Thrumster WWS Amendment Report RTS

Response to Submissions

Port Macquarie Hastings Council

22 July 2025

Figure C.2 Modelled May 2025 peak flood extent relative to the proposed Thrumster Wastewater Treatment Plant site

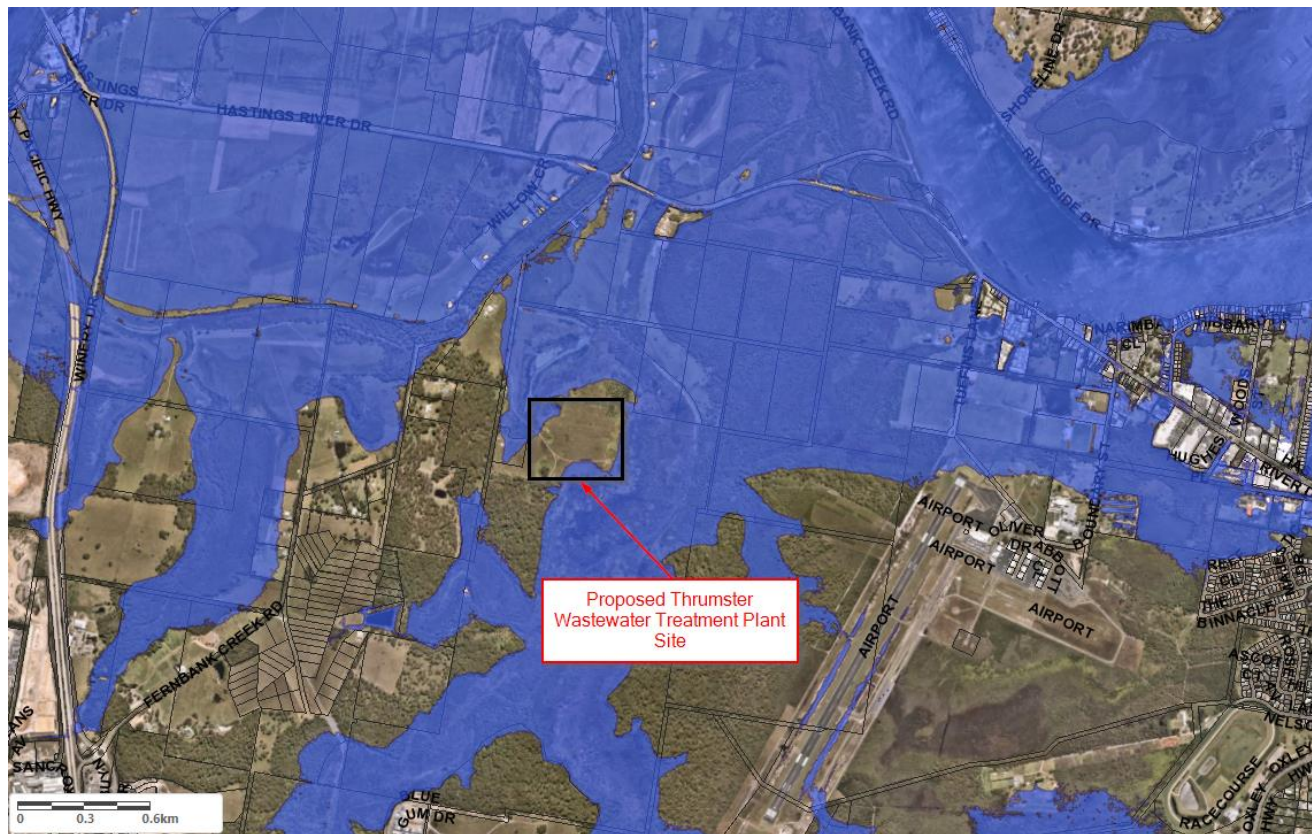
<p>Flooding</p>	<p>Flooding context</p>	<p>Flood response saved in Appendix C and Beca H20 have provided an assessment of plant performance during the May flood event, see Appendix D.</p>
<p>Power supply</p>	<p>Power supply installation changes.</p>	<p>The operation of the new WWTP will require a new electrical connection to the regional electricity network and Council has been in a process of ongoing liaison with Essential Energy. The preferred electrical alignment presented in the EIS was not accepted by Essential Energy and a new Connection Investigation Response (ECN-022950/MNC000088) was provided to Council on 07 April 2025. The Connection Investigation Response prepared by Essential Energy included a number of alternatives for consideration and Council has subsequently undertaken multi-criteria analysis and selected the Primary Feed Alternative 2 which involves extending an electrical connection along the WWTP access road.</p>

As shown in the May 2025 flood extent map (Figure C.2) the proposed Thrumster Wastewater Treatment Plant site was not impacted by the May 2025 flood. The modelled flood level was approximately 2.5 m AHD with the site being about 0.5 m higher.

Figure C.6 The proposed wastewater plant layout showing the raised embankment compared to the 1% AEP flood event level, which is 1.55 m higher than the May 2025 event

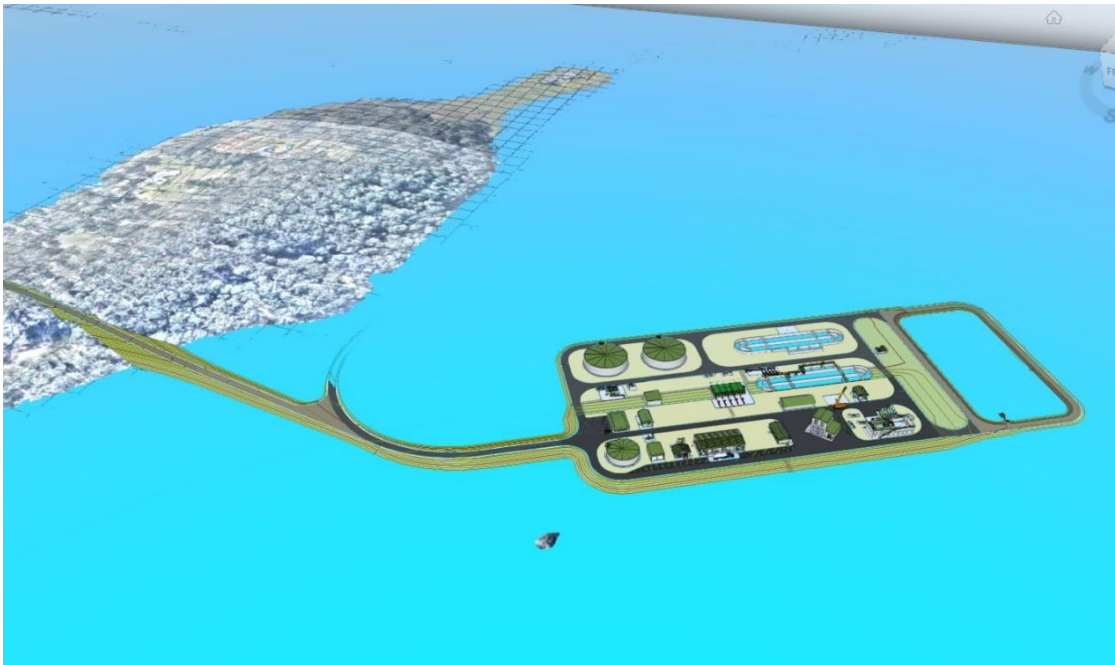
Outdated water modelling	Outdated and inaccurate water modelling.	<p>Concerns Flood modelling has used outdated data / Historical flood levels on the site</p> <p>Flood modelling is a scientific process used to simulate how water moves across land during rainfall events, helping predict where and how flooding might occur. These models incorporate topography, land use, drainage infrastructure, and rainfall data to estimate water flow and accumulation. To account for climate change, flood models integrate projections of future rainfall patterns, sea level rise, and increased storm intensity based on climate scenarios.</p> <p>Flood models can become outdated when development alters topography, changing how water flows and accumulates across the landscape. In the specific context of the Thrumster WWTP. The surrounding landscapes and topography of Fernbank Creek and the site have remained largely unchanged for decades.</p> <p>The primary data utilised for the EIS assessment is from the Hibbard Precinct Flood Study.</p> <p>Refer to Table 3.3 of the Water Resources and Flooding Assessment for reference to the key sources and flood levels adopted in the assessment.</p>

Primary Category	Issue Sub-category	Issue description	Response to submission
	Flooding	Fernbank Creek is a central disaster zone which experiences frequent flooding. The proposed hardstand surfaces would increase flood risk.	<p>Concerns about site accessibility during times of flood</p> <p>The facility will be accessible via two access roads:</p> <p>Primary Access Road: This road will be used continuously throughout both the construction and operational phases. However, during flood events, there is a potential for inundation, which could lead to restricted or complete loss of access to the site.</p> <p>Secondary/Emergency Access Road: the concept design includes for a flood-proof, all-weather access road to provide access to the TWWTP exclusively during flood events or emergencies.</p> <p>It was investigated and identified that the most suitable location for the emergency access road traverses over private land located on the property at 555 Fernbank Creek Rd. This emergency access road will be above the 1% Annual Exceedance Probability (1 in 100 year flood) level and will allow access and egress from the site during flooding events that impact the primary access road into the site. The secondary access will link into Fernbank Creek Rd west to the Pacific Highway Fernbank Creek interchange.</p>  <p><i>Figure 1: the proposed wastewater treatment plant layout showing the raised embankment compared to the 1% AEP flood event level, which is 1.55m higher than May 2025 event</i></p> <p>Concerns about floodplain loss not being included in the modelling</p> <p>In relation to potential impact on flooding because of filling associated with the site the assessment suggests the project is consistent with policy requirements for both commercial and critical infrastructure development.</p>

The proposed Thrumster Wastewater Plant will be constructed on a raised earth embankment/platform above the 1%AEP (1in100) flood event level, as shown in Figure C.6.
